SUNDRY NOTICES AND REPORTS ON WELLS (DO NOT USE THIS FORM FOR PROPOSALS TO DRILL OR TO DEEPEN OR PLUG BACK TO A DIFFERENT RESERVOIR. USE "APPLICATION FOR PERMIT" (FORM C-101) FOR SUCH PROPOSALS.)		WELL API NO. 30-005-20472

NMOCD plans to plug this well in accordance with the attached procedure and any agreed modifications there to.

Cato San Andres #201

Plug And Abandonment Procedure

Proposed Wellbore Diagram

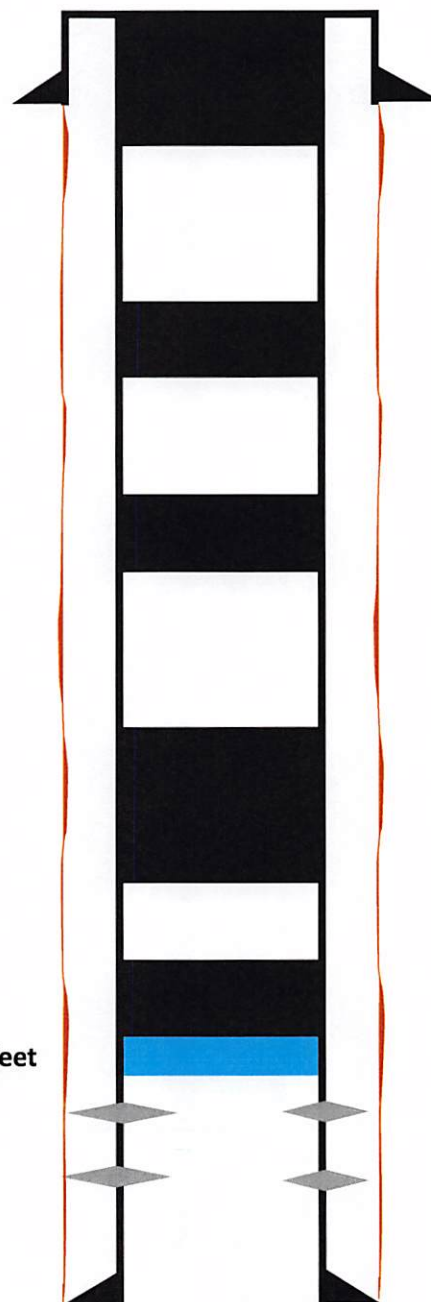
Created By	Condition	Condition Date
jagarcia	Plugs must be inside/outside if no cement exists outside casing	11/30/2023
